Schematics of EUT

FCC ID: SGXMPIDA-610

DA-610 PC BOARD SCHEMATIC

REV B

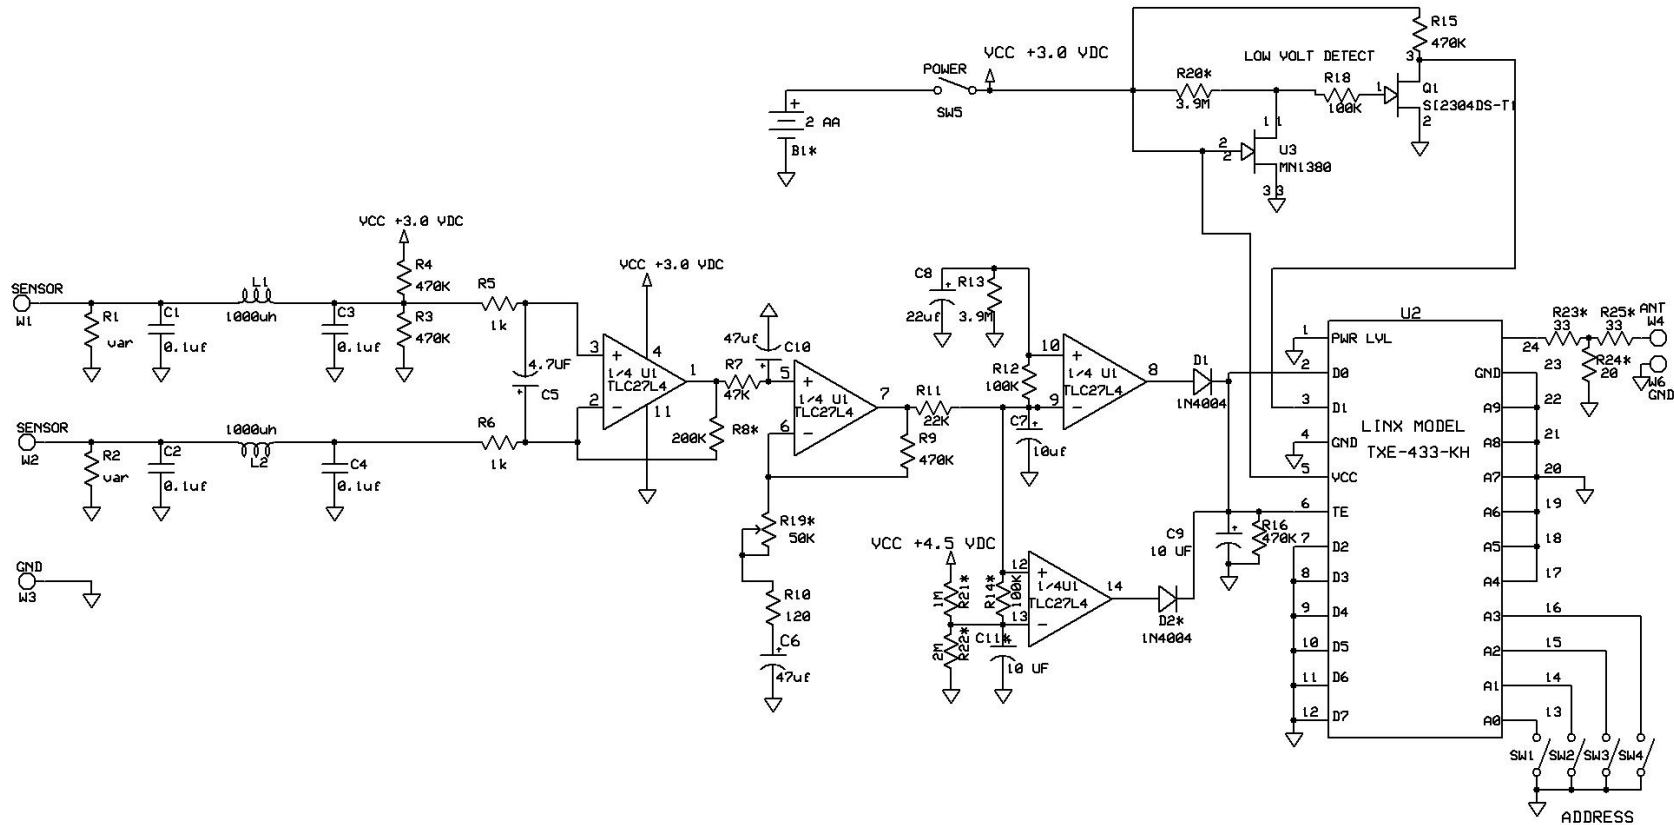
REV B CHANGES
 CHANGE B1 FROM 4 - AA CELLS TO 2 - AA CELLS
 CHANGE VCC FROM + 6.0 VDC TO +3.0 VDC
 CHANGE R8 FROM 1M TO 200K OHM
 CHANGE R19 FROM 5K TO 50K OHM
 DELETE U4 BBA-519
 DELETE W5 AND W7
 ADD DIODE D2 1N4004
 ADD RESISTORS R20, R21, R22, R23, R24, R25
 ADD CAPACITOR C11
 DELETE R17
